Model: Model C-P1		Date: 17-Sep-03	No.: RG094001
Subject: Printer Controller Firmware History		Prepared by: T.Shintani	
From: 1st Technical Support Sec. Service Support Dept.			
Classification:	<input type="checkbox"/> Troubleshooting <input type="checkbox"/> Part information <input checked="" type="checkbox"/> Action required <input type="checkbox"/> Mechanical <input type="checkbox"/> Electrical <input type="checkbox"/> Service manual revision <input type="checkbox"/> Paper path <input type="checkbox"/> Transmit/receive <input type="checkbox"/> Retrofit information <input type="checkbox"/> Other ()

Model: Model C-P1		Date: 26-Apr-04	No.: RG094002
Subject: Engine Board		Prepared by: A. Ishiyama	
From: 1st Technical Support Sec. Service Support Dept.			
Classification:	<input type="checkbox"/> Troubleshooting <input type="checkbox"/> Mechanical <input type="checkbox"/> Paper path <input type="checkbox"/> Other ()	<input type="checkbox"/> Part information <input type="checkbox"/> Electrical <input type="checkbox"/> Transmit/receive	<input checked="" type="checkbox"/> Action required <input type="checkbox"/> Service manual revision <input type="checkbox"/> Retrofit information

Impo

Minor Modification of old G0965116 Engine Board to its New Version

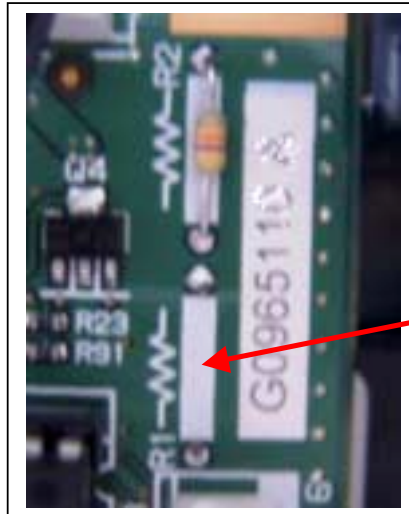
The old engine board (G0965116) contains two resistors, R1 and R2, but the new board for NA (G0985102) contains only R2 and the new board for EU/Asia (G0985104) contains only R1.

1. If the old engine board is already installed in the machine:
 - i) Open the front door.
 - ii) Remove the operation panel (2 hooks, 1 harness).
 - iii) Remove the rear cover.
 - iv) Remove the top cover (4 screws).
 - v) Remove the left cover (2 screws).
2. **For NA version**
 Remove R1 as shown below using a pair of wire cutters (nippers).

Remove R1 using a pair of wire cutters

In the same manner, **remove R2 using a pair of wire cutters.**

Old P/N	New P/N	Description	Q'ty	Int	Page	Index	Note
G0963272	G1103272	COVER: MANUAL FEED TABLE	1	O/O	3	10	-

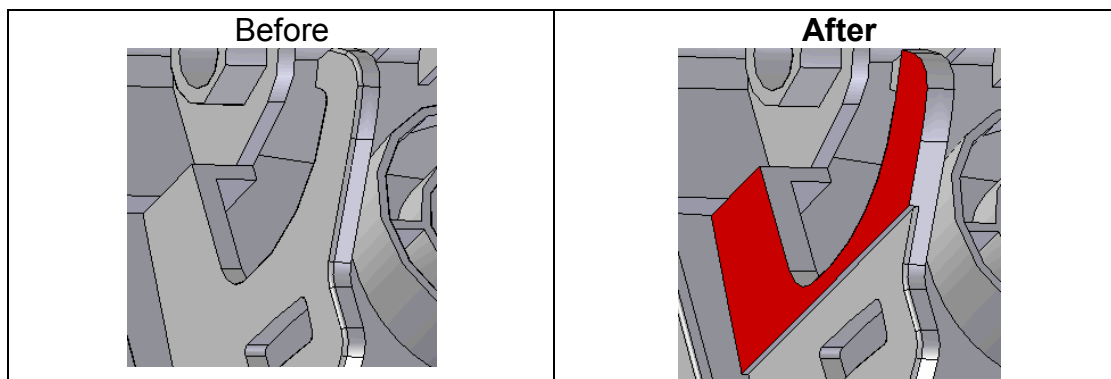
Change: The shape of the hook was changed.

Reason: To improve the durability of the hook.
